ARTS & EVENTS DISTRICT
II

ADDENDUM NO. 2

DATE: October 22, 2002
TO: PROSPECTIVE BIDDERS
FROM: SASAKI ASSOCIATES, INC.
64 Pleasant Street
Watertown, Massachusetts 02172
PROJECT: ADDISON ARTS & EVENTS DISTRICT
Addison, Texas

SCALE NONE	DWG. NO. FMC-ADB	REV. A
DATE 1/99

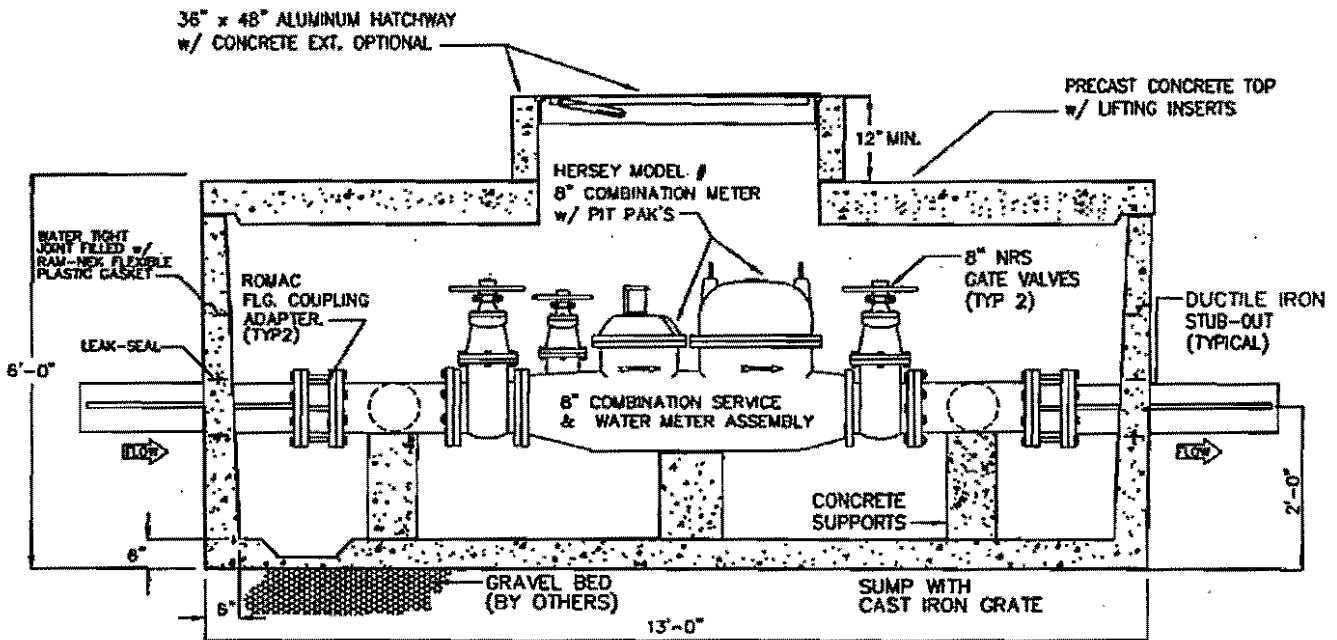
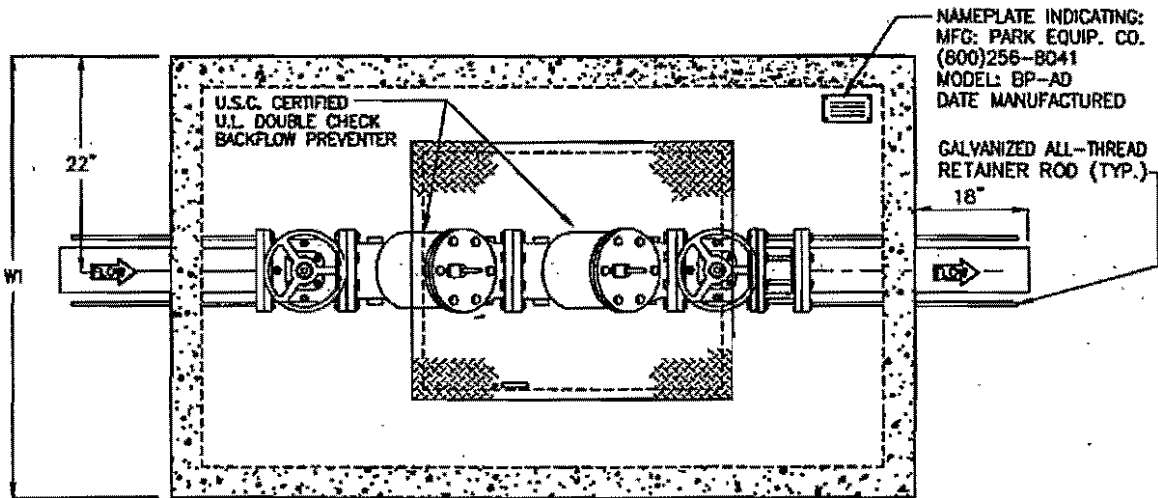
1. Delete Drawing No. DDBP-AD regarding backflow preventer assembly.
2. Add Drawing Nos. FMC-AD8 and BP-AD (attached) for Town of Addison approved water meter with vault and backflow preventer with vault.

Typical Drinking Fountain Connection

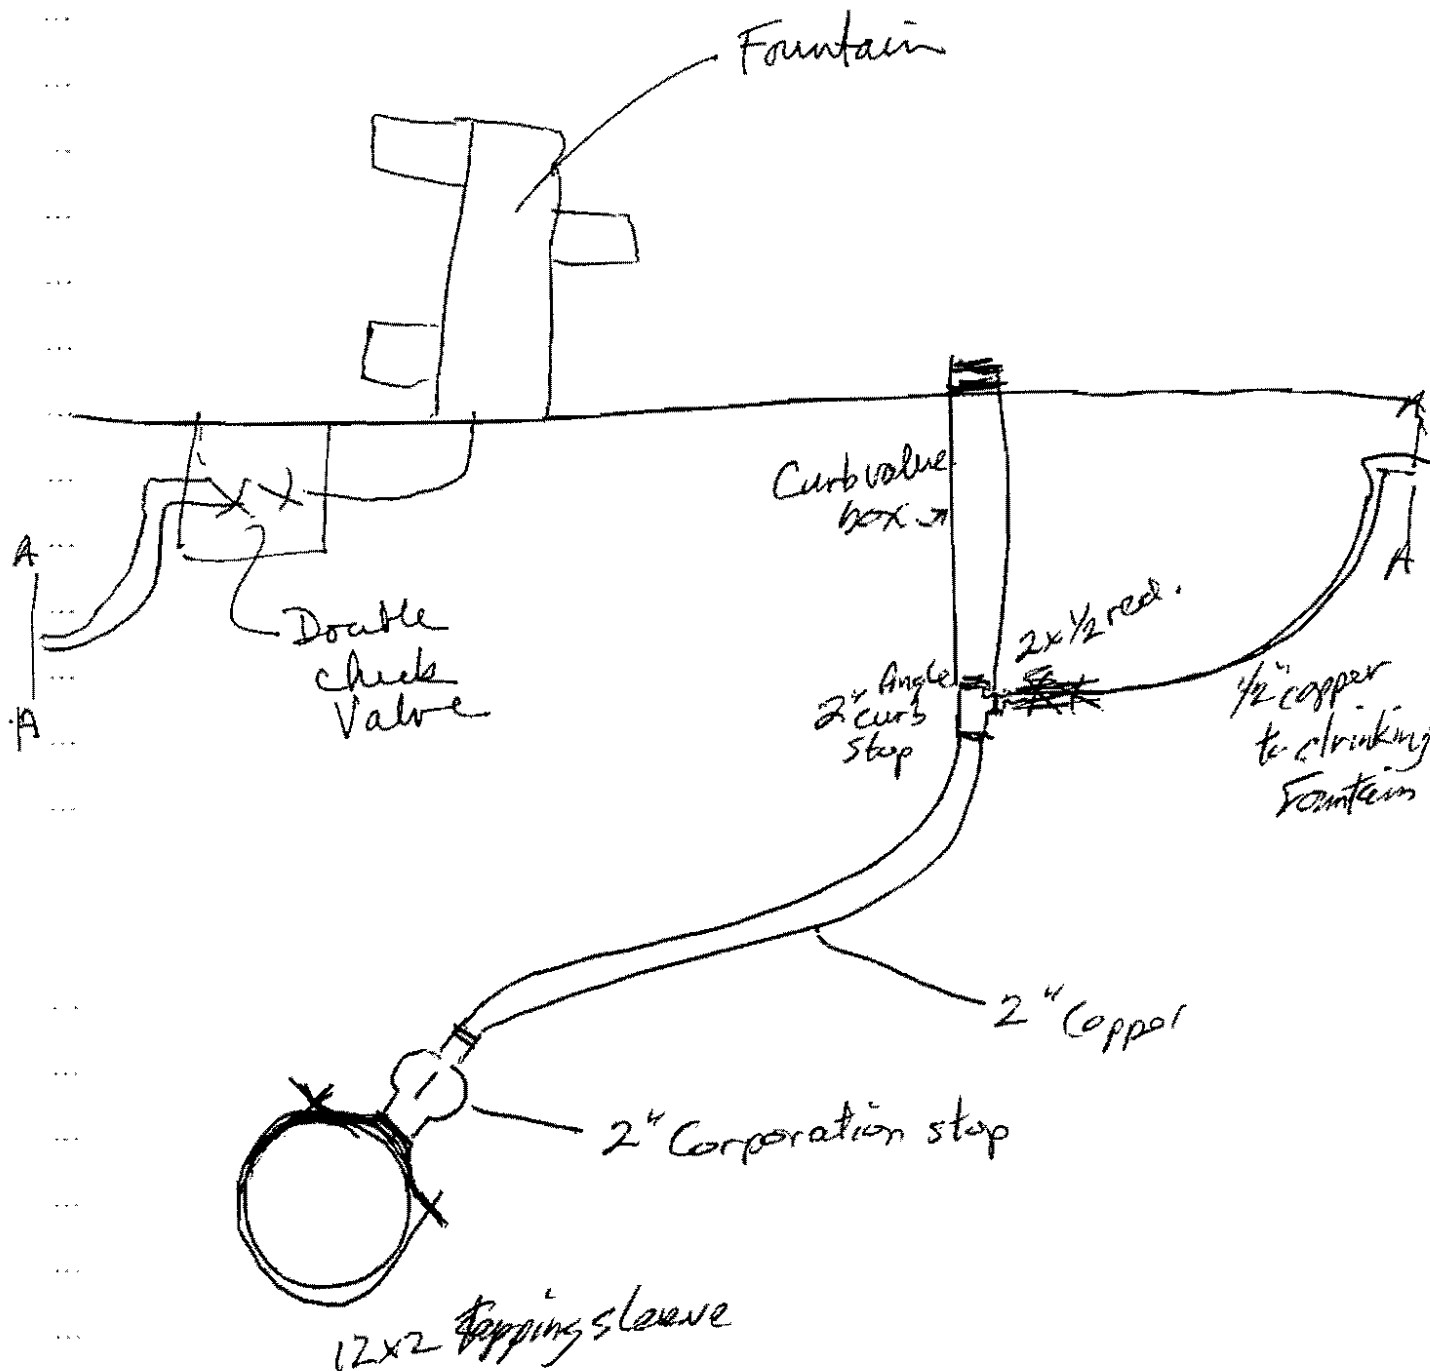
1. Detail 4: Revise dimension of concrete pads at cover and pipe bedding, including notes.
2. Detail 5: Revise dimension from hydrant to valve box, height of hydrant above grade, and revise notes.
3. Add Detail 6 for typical drinking fountain supply pipe connection.
4. Delete typical hydrant layout plan diagrams.
